Final Implementation Document
for the Interim Response Action for
Building 1727 Sump
at the Rocky Mountain Arsenal

COMMENTS ON THE DRAFT IMPLEMENTATION DOCUMENT
FOR THE INTERIM RESPONSE ACTION FOR THE
1727 SUMP

RESPONSE TO U.S. EPA REVIEW COMMENTS ON
THE DRAFT IMPLEMENTATION DOCUMENT FOR THE
INTERIM RESPONSE ACTION FOR BUILDING 1727 SUMP

RESPONSE TO STATE OF COLORADO REVIEW COMMENTS
ON THE DRAFT IMPLEMENTATION DOCUMENT FOR THE
INTERIM RESPONSE ACTION FOR BUILDING 1727 SUMP

FIGURE 4-1
AA/GAC TREATMENT SYSTEM FOR SUMP 1727

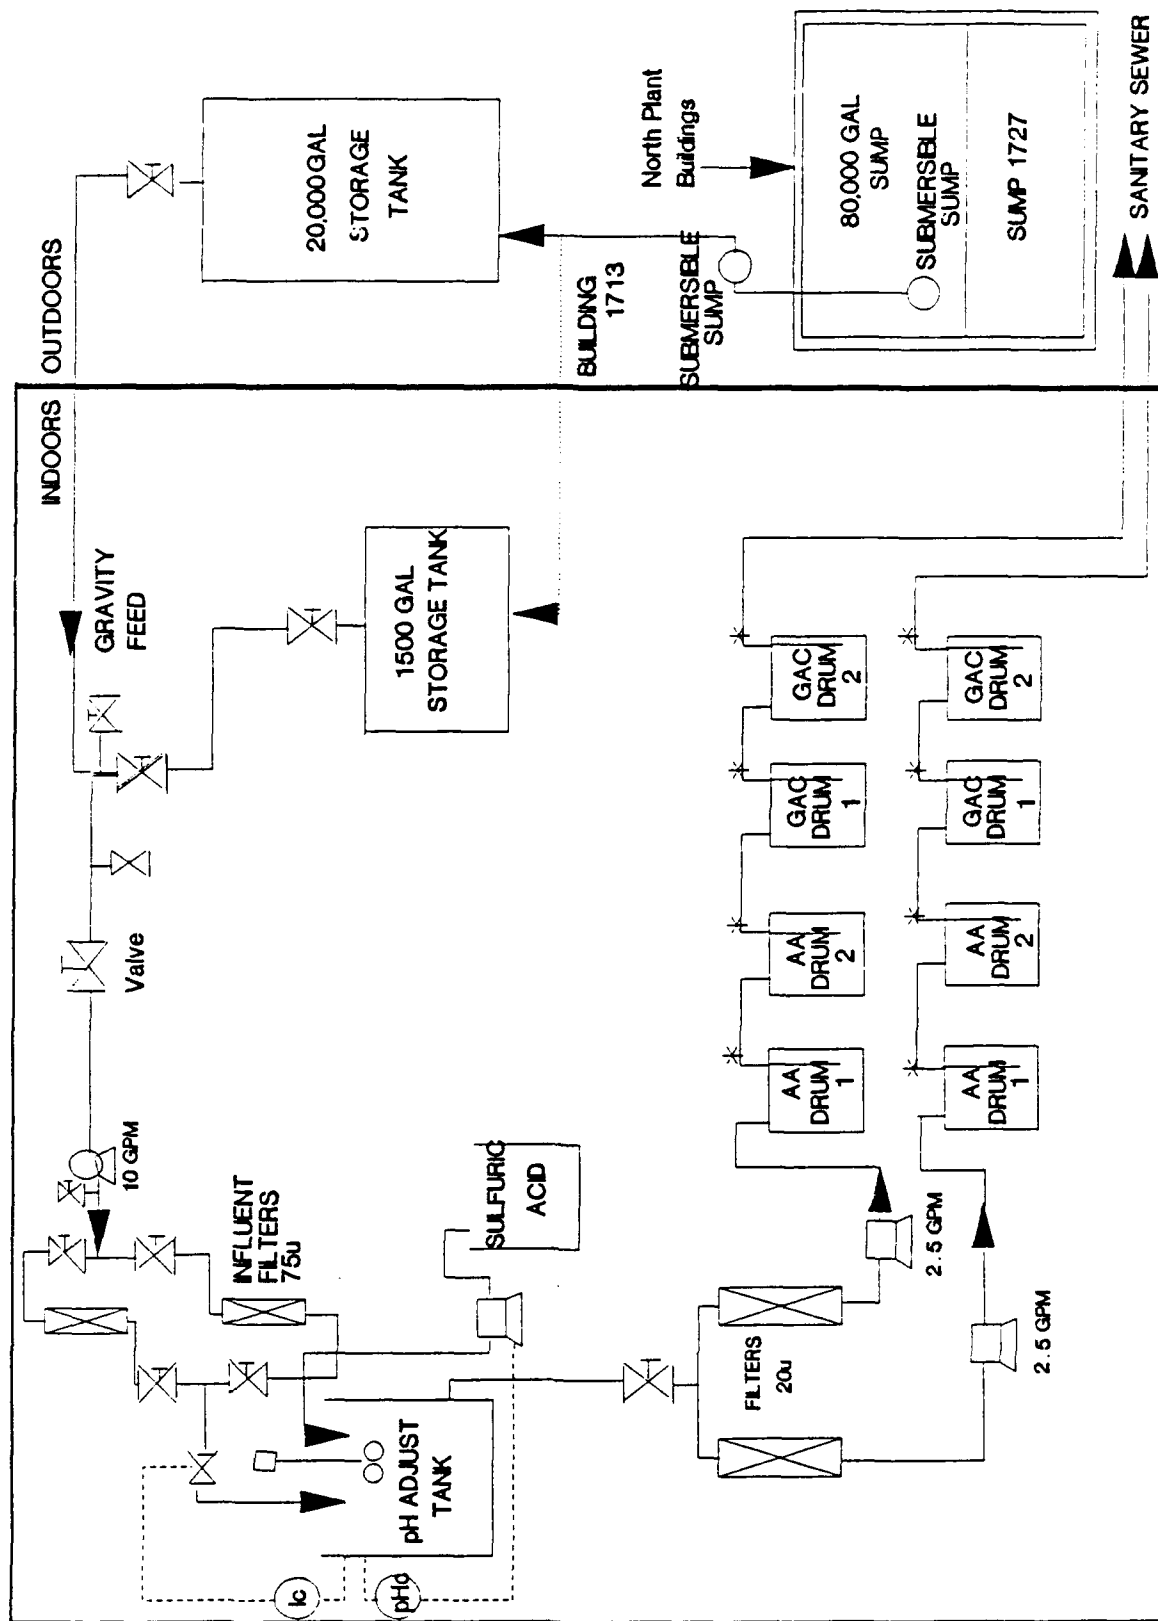
3. Since this is a currently operating system, it is assumed that no detailed design document will be prepared for this IRA. EPA, therefore, requests that this document specify flow rates, pressures attained, materials of construction, and frequency of inspection of the pumps, feed lines, etc. Does a separate O&M document exist for this system or is the information here inclusive of that; if so, please expand the text to more fully detail O&M.

Response: Since this document represents the O&M Manual for the treatment system, Section 4.0 Treatment System Description has been expanded to more fully detail O&M and specify additional information regarding components of the system.
